MEMORANDUM

To: The Design Advisory Board
From: Mary O'Neil, AICP, Associate Planner
RE: ZP 12-0014 CA 26 Grove Street
Date: August 23, 2011

Request: 20' x 20' three story addition on the back of an existing single family house; remove lower driveway, extend upper driveway to accommodate 2 cars, remove collapsed garage.

1st STORY FLOOR PLAN

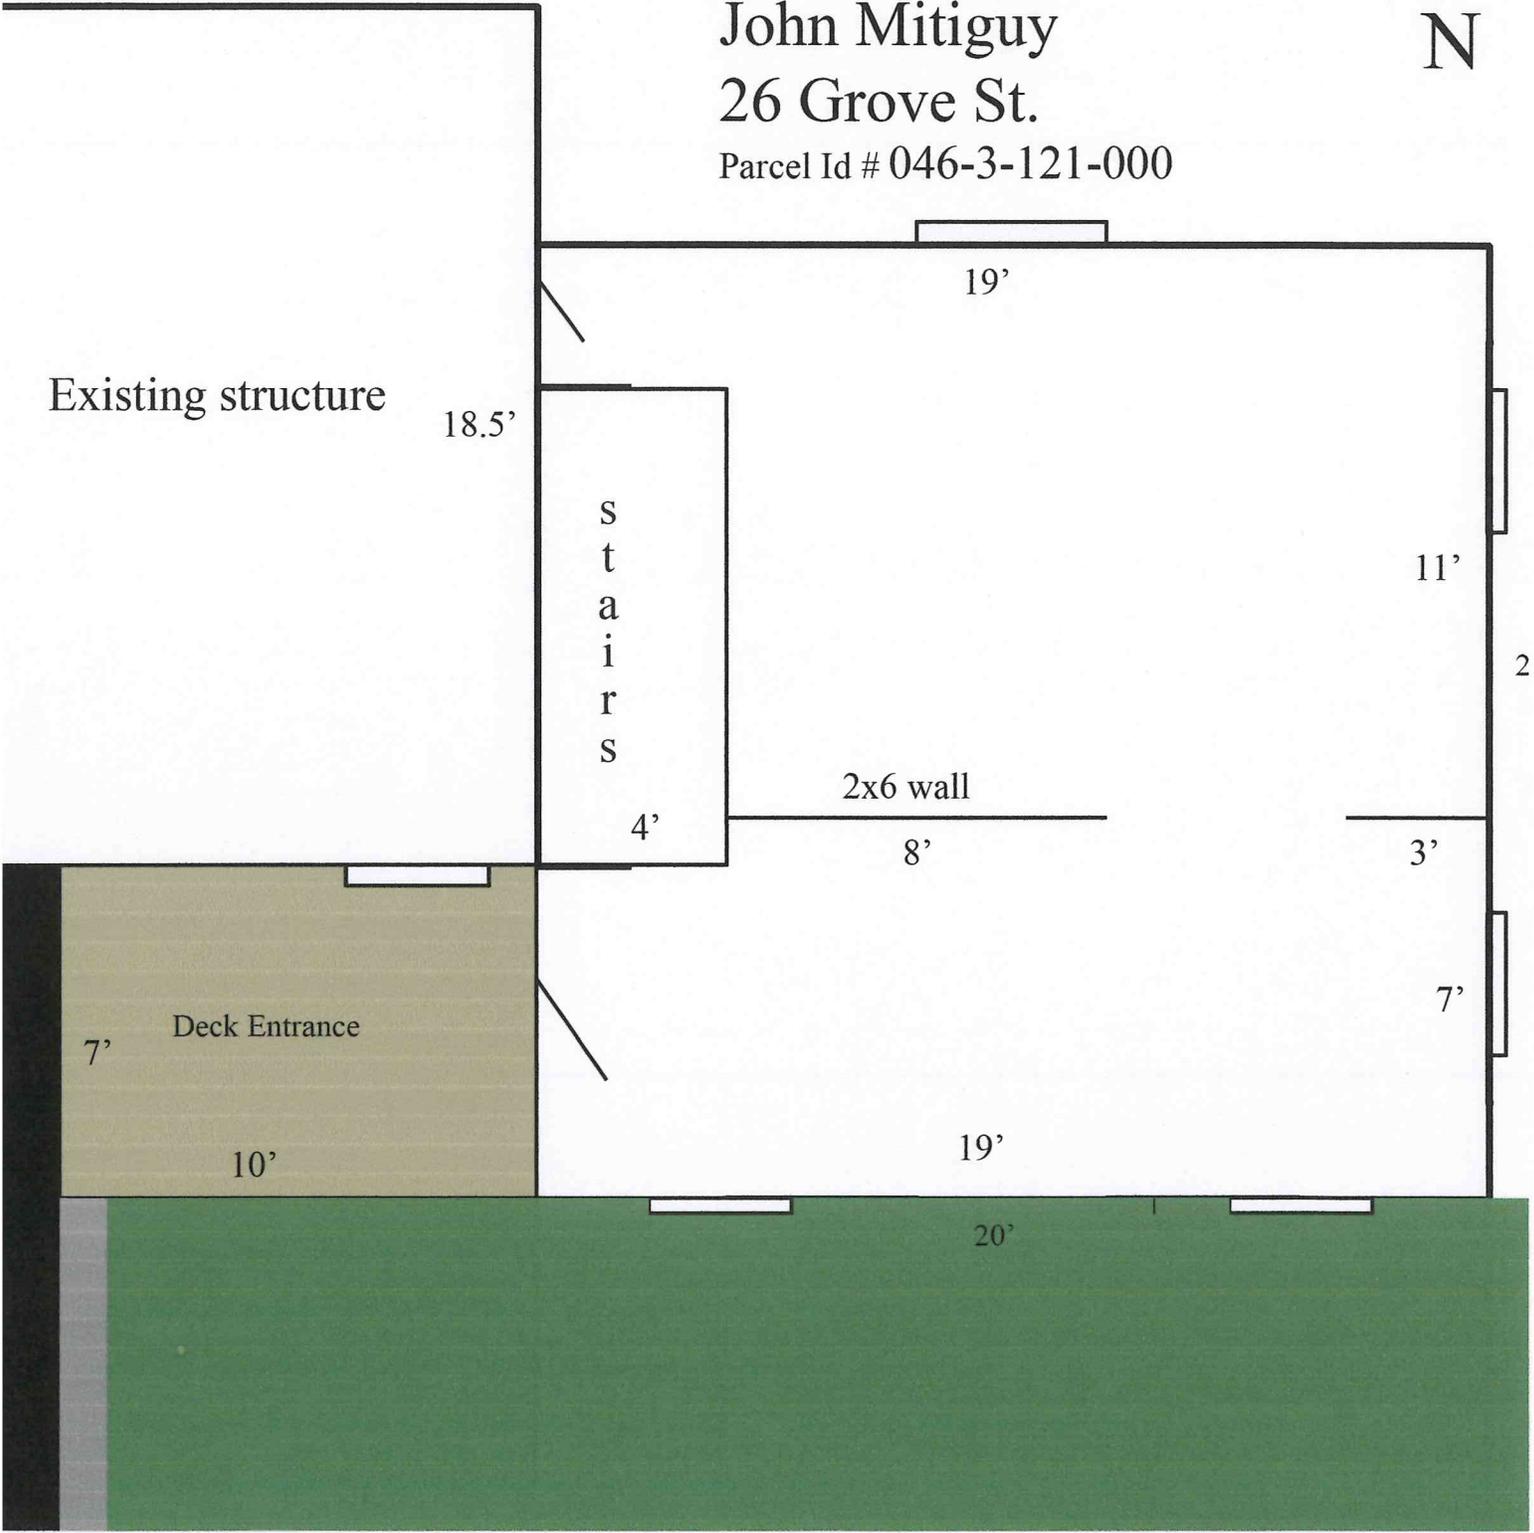
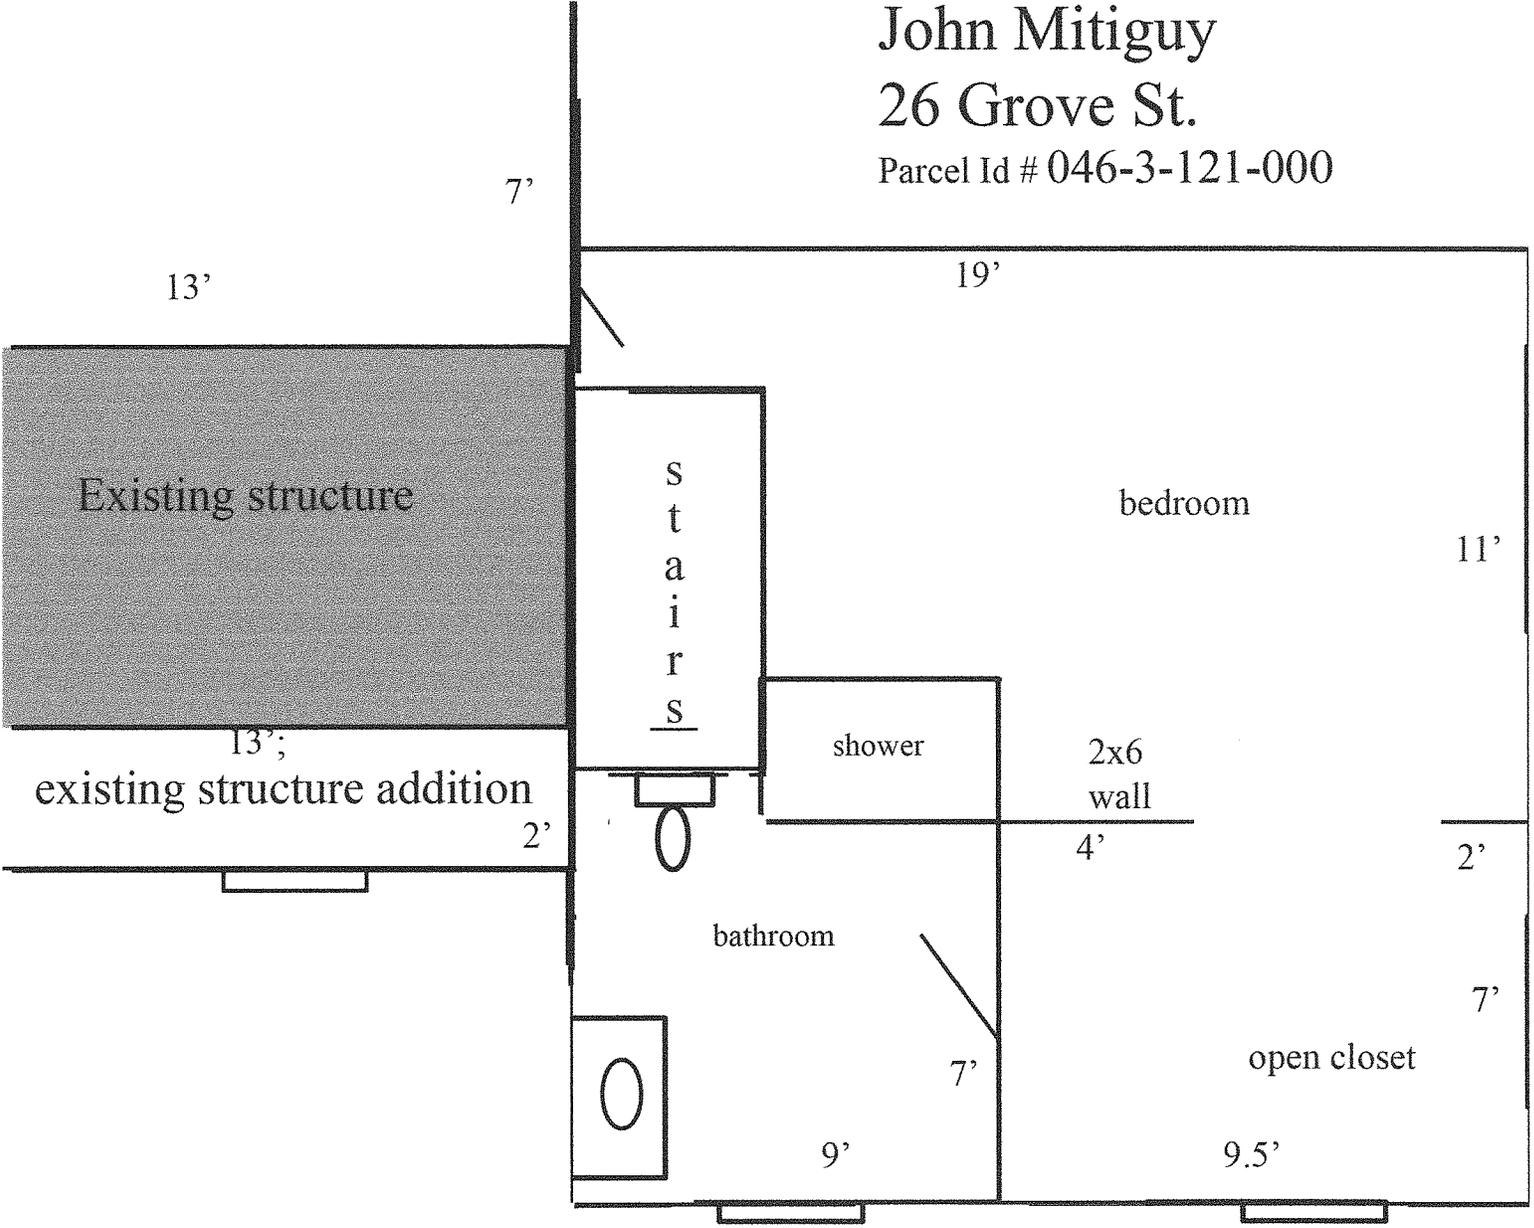
3. Design assistance is strongly recommended to maximize potential and to assure functionality of the proposed addition. As designed, occupants must walk through bedrooms or closets to reach other bedrooms and bathrooms. Professionally prepared plans, including floor plans, should be submitted for further review. Additionally a floor plan for the lower/basement level of the proposed addition shall be required.

4. It continues to appear that an additional dwelling unit is proposed. The submitted floor plan appears to be a living room/kitchen on the first story of the addition, with two bedrooms on the upper floor. 26 Grove Street may not be permitted as a duplex due to the size of the lot (<10,000 sq. ft in the RL zone) and insufficiency of parking.
